MODEL: FR600V, FR651V, FR691V, FR730V, FS481V, FS541V, FS651V, FS691V, FS730V, FX481V, FX600V, FX651V, FX691V, FX730V

TITLE: ROCKER ARM CHANGE

FACTORY DIRECTED MODIFICATION

Kit Detail

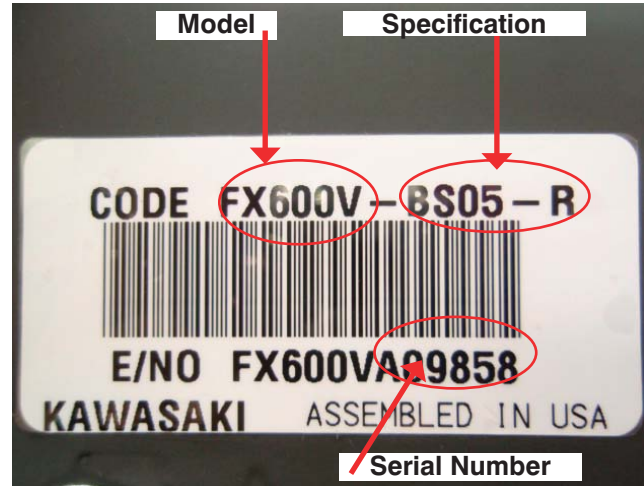
Certain FR, FS, FX, Engine Models may experience rocker arm failure and/or premature wear. Rocker arm and rocker case gasket part kits have been made available to eliminate this possibility during engine operation.

Item	Part Number	Qty
Arm-Rocker	12016-2066	4
Gasket	11061-7083	2

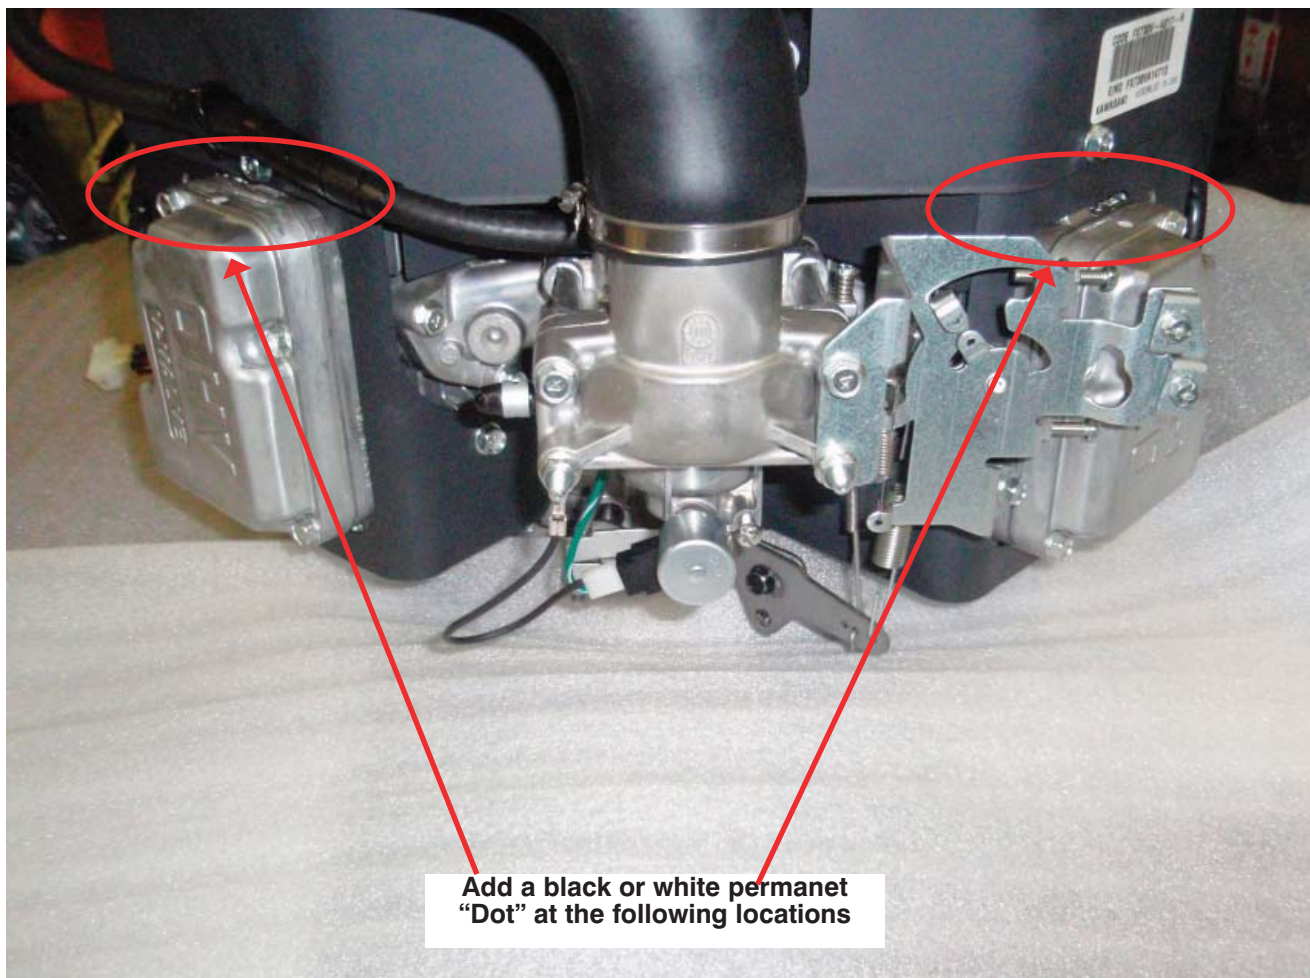
4. As a quick reference to identify that the FDM has been applied, please add a non-fading permanent black or white "Dot" on the top of each rocker case as shown below.
